# RECALL 24V272 / 2024-227 REMEDY INSTRUCTIONS

## 206346 Range and Slide-in Deactivate Lights Instructions

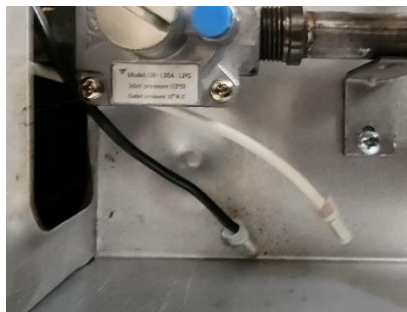
3. Locate the red and black wires that connect to the coach wiring (Coach wiring color may vary). Cut this wire directly behind the connector using a pair of electrical cutters.

4. Crimp the Crimp Caps(233759) to incoming 12V positive and negative to prevent lights from being reattached.
